20240610 – BL000B – MULTI-BUILDING – BL107, BL405 – Replace Humidifiers
Addendum 2

November 4, 2025

Changes to the Drawings

M201

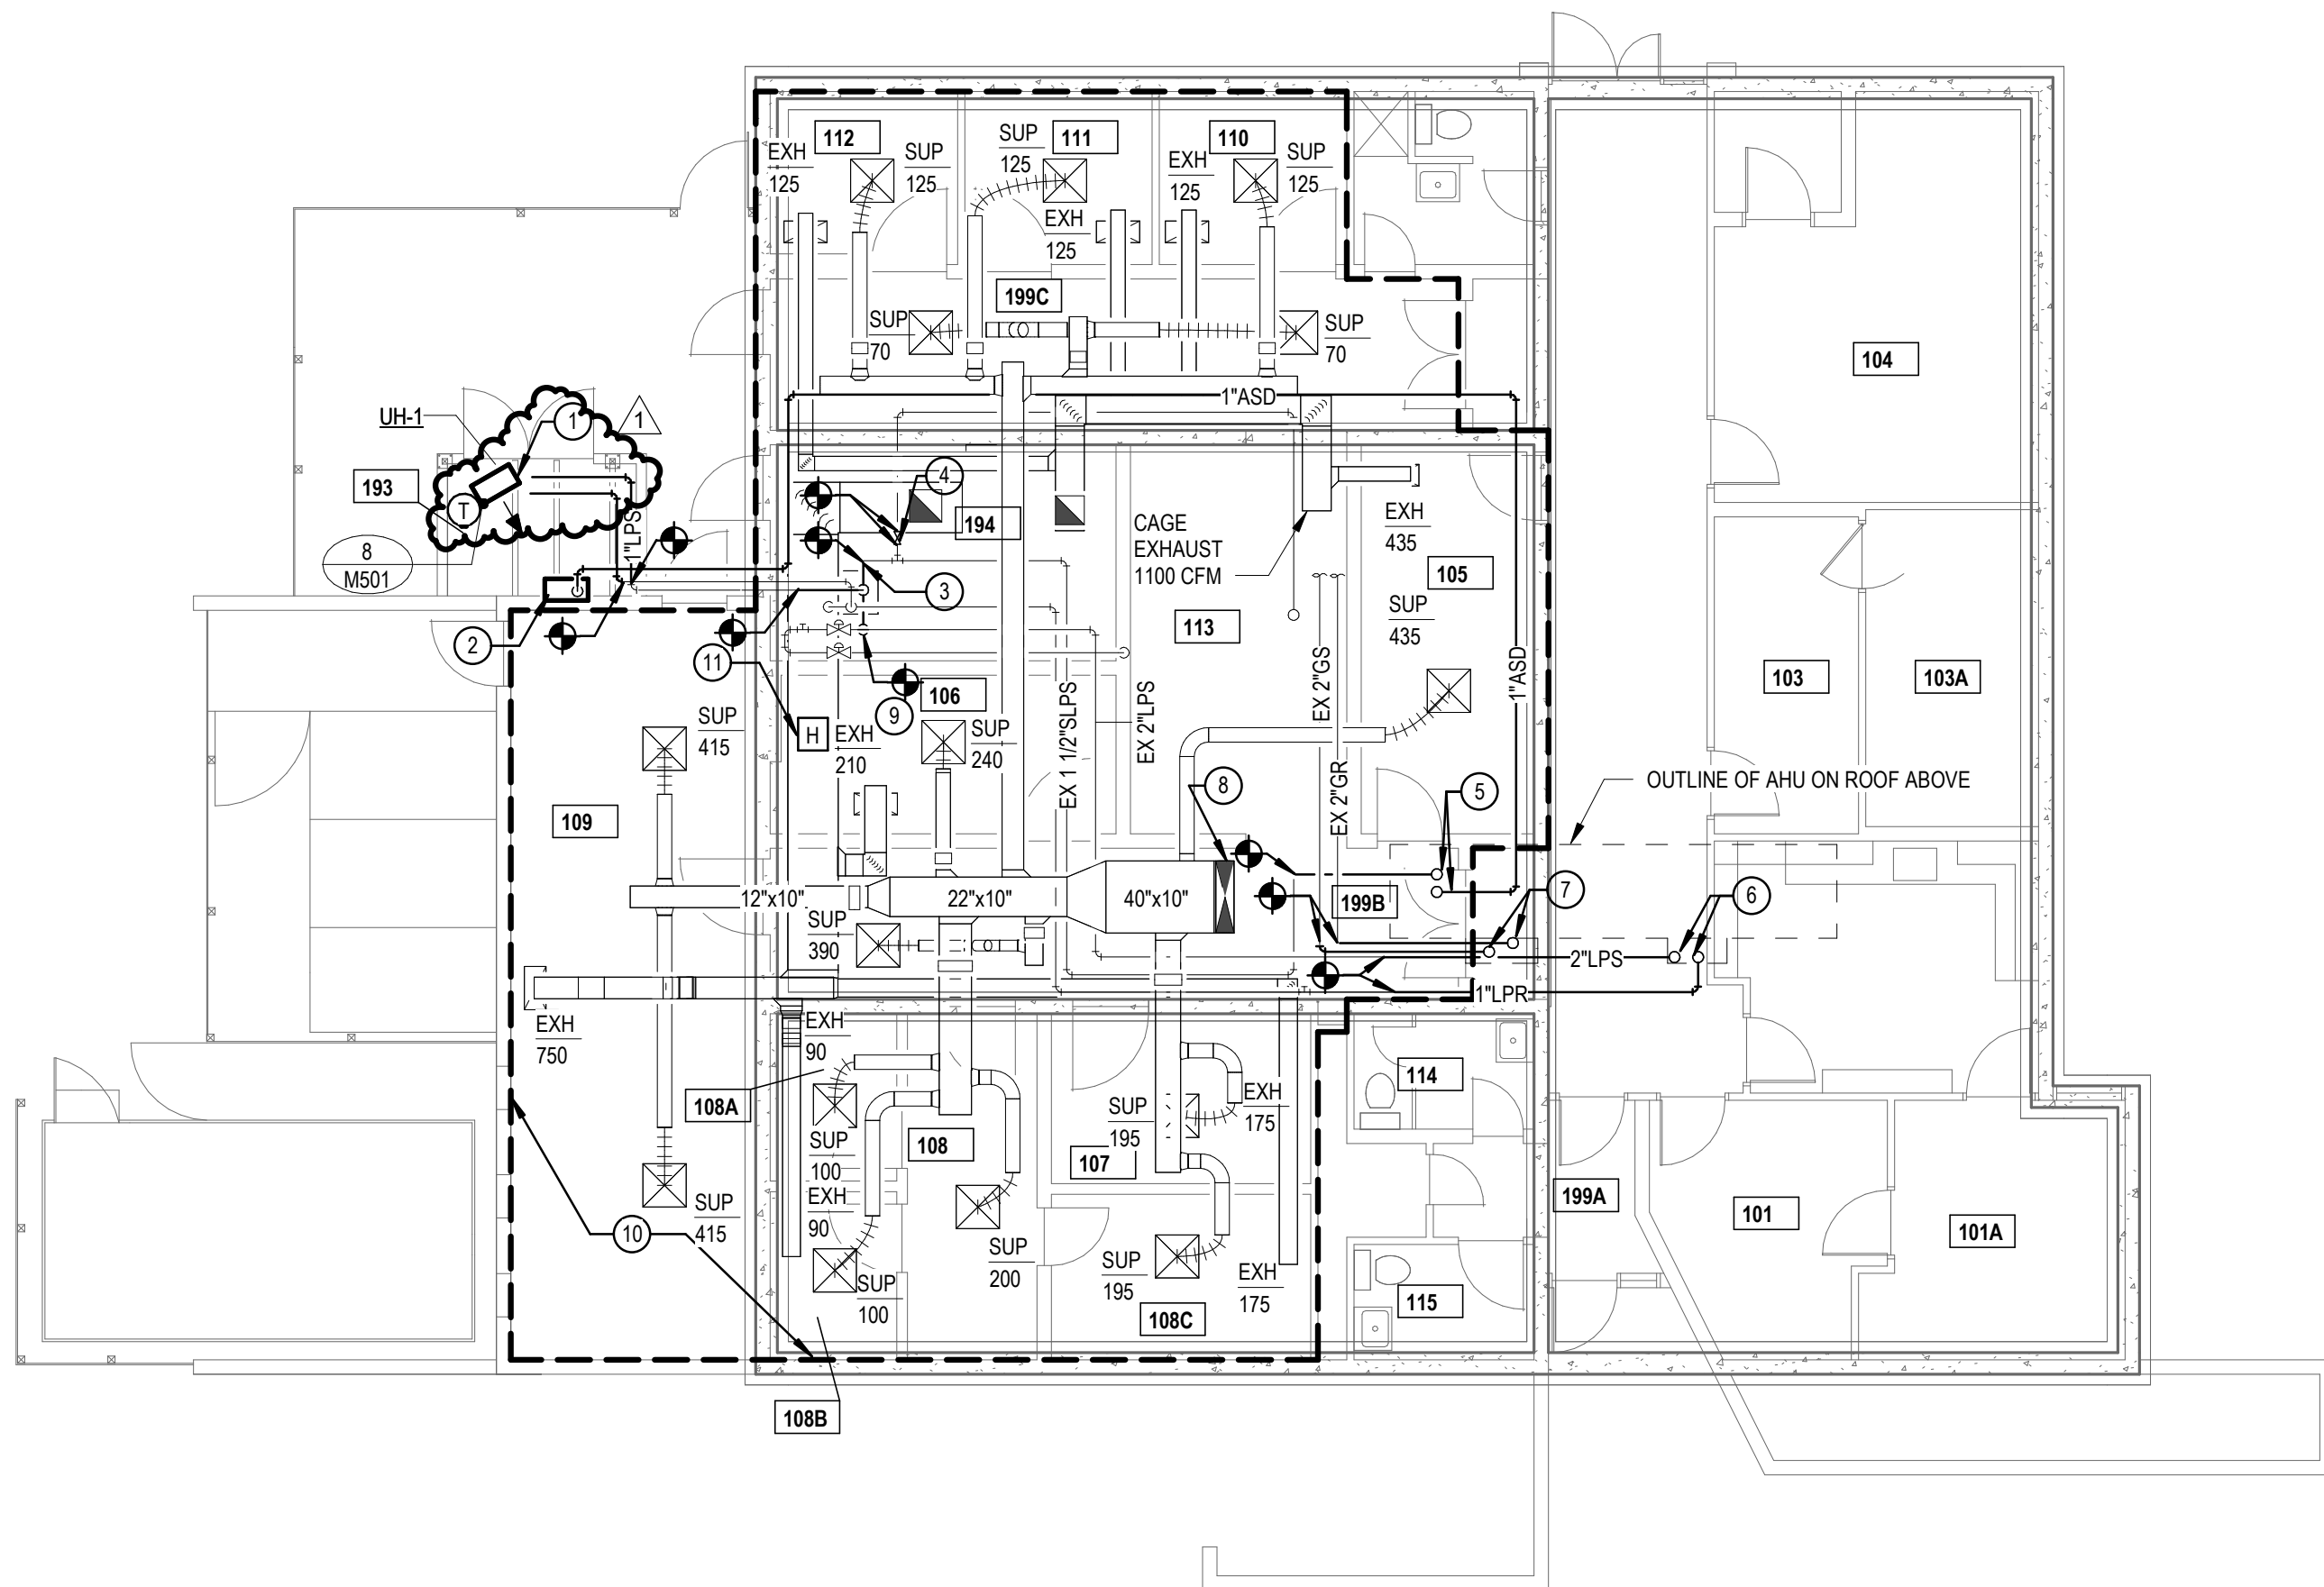
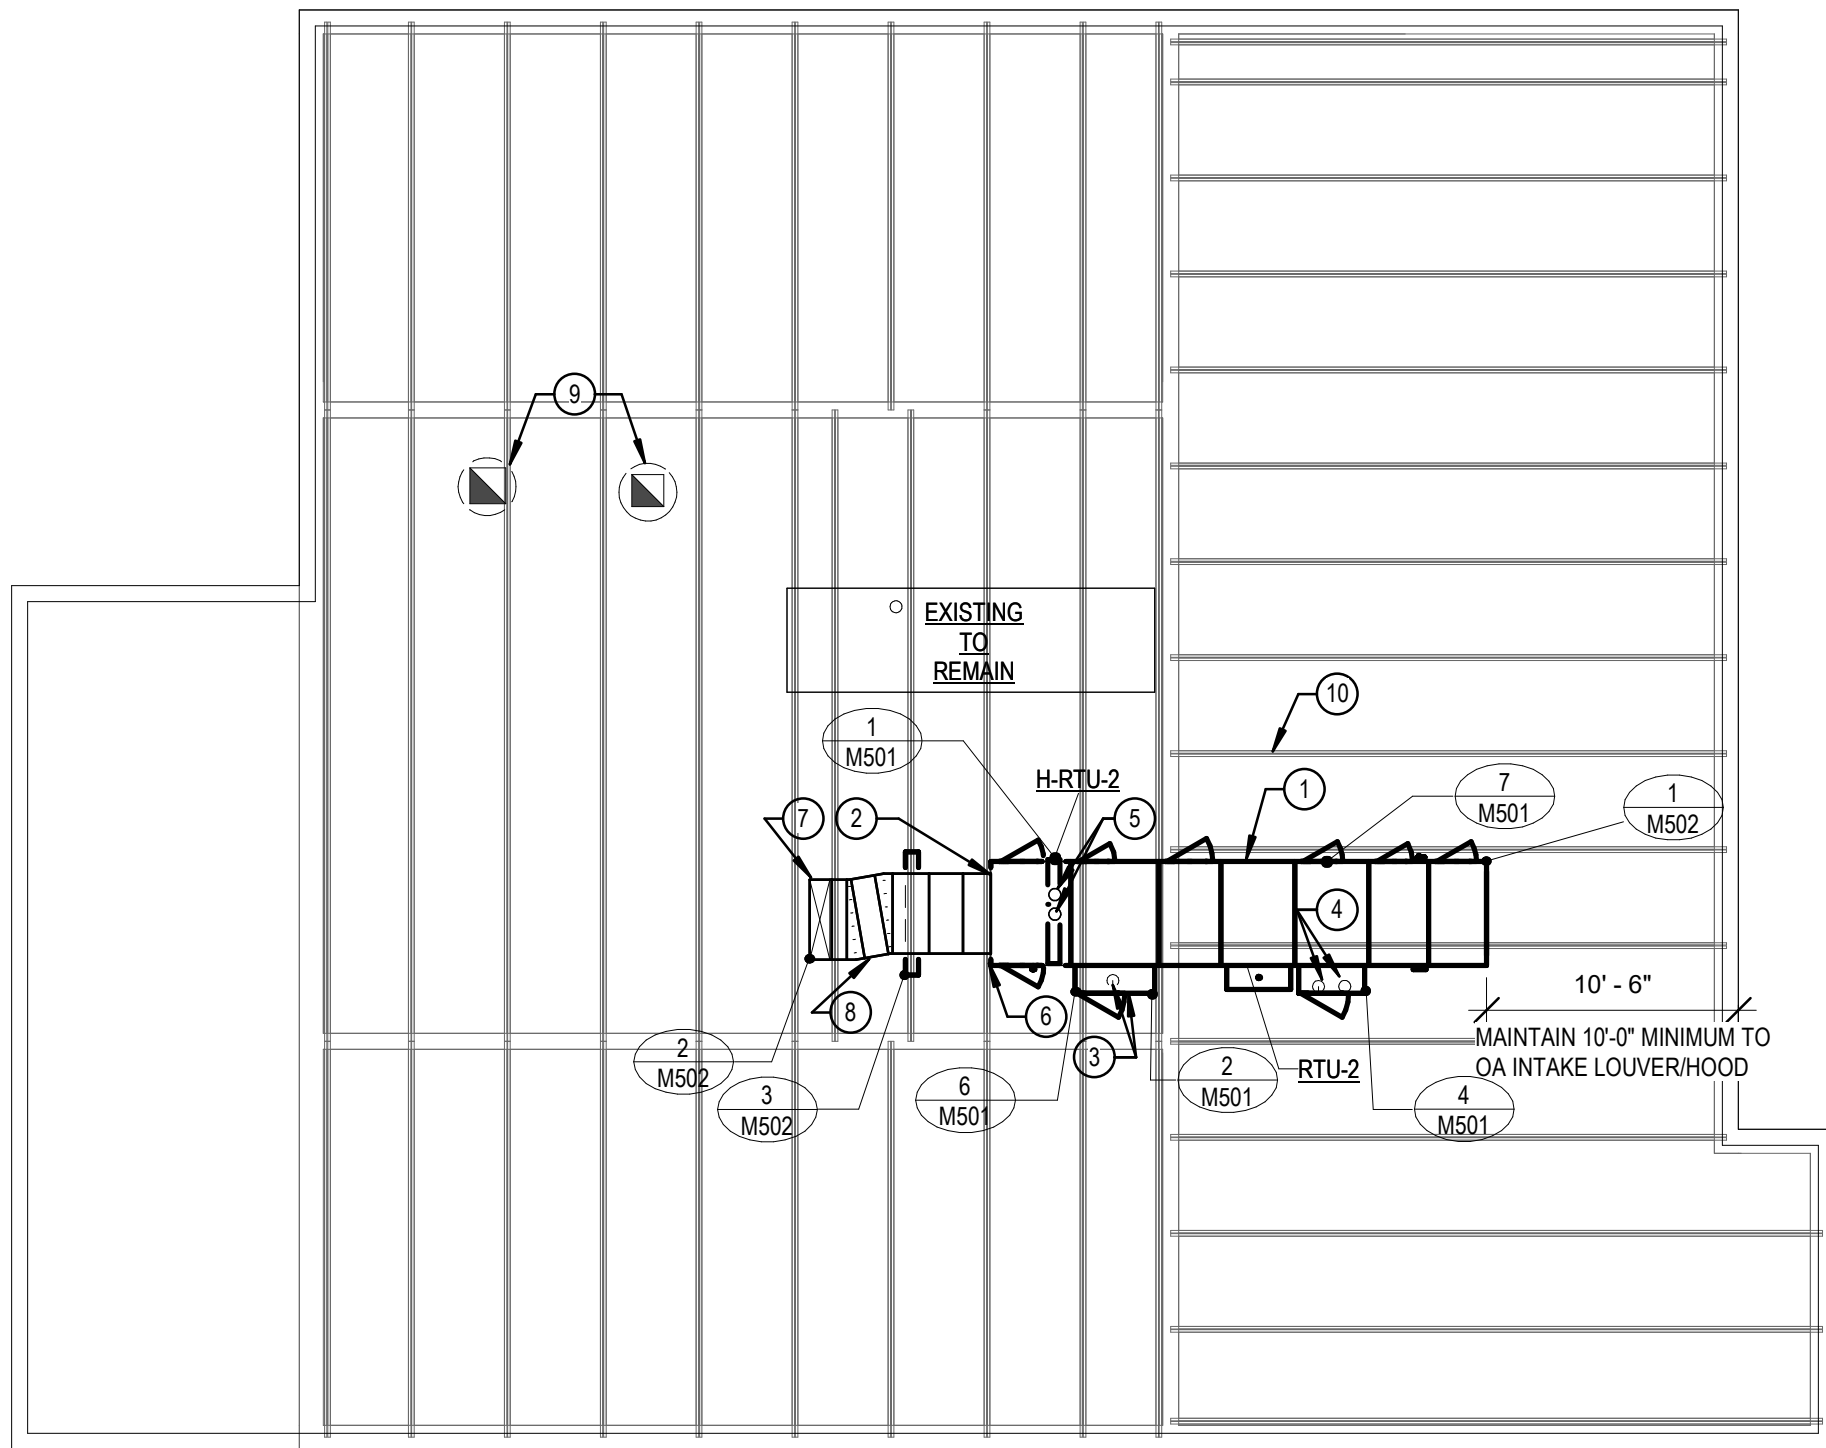
Question 2: In the mechanical room 193, it shows a location for the new steam unit heater, but I believe that is the same location as the existing water heater. With all the demo, I thought the opposite corner might be a better location. Please advise.

Question 4: On sheet M201, detail 1, note 9; it says connect to LPS main downstream of LPS PRV. Please confirm that the PRV is an existing PRV.

Answer 2: Revise the location of the unit heater as shown in the revised drawing.

Answer 4: The PRV is existing.

- PROVIDE UNIT HEATER BOTTOM +/- 8'-0" AFF. FIELD VERIFY EXACT LOCATION.
- CONDENSATE COOLER PROVIDE WITH HUMIDIFIER. CONNECT DOMESTIC WATER FROM THE EXISTING BACKFLOW PREVENTER IN THIS ROOM TO THE CONDENSATE COOLER. PIPE DRAIN TO FLOOR DRAIN.

- EXISTING 40X10 SUPPLY DUCT UP. CONNECT TO NEW DUCT FROM ROOF. VERIFY EXISTING SIZE AND TRANSITION AS REQUIRED.
- CONNECT 1-1/2" LPS TO EXISTING LPS MAIN DOWNSTREAM OF LPS PRV IN MECHANICAL ROOM.
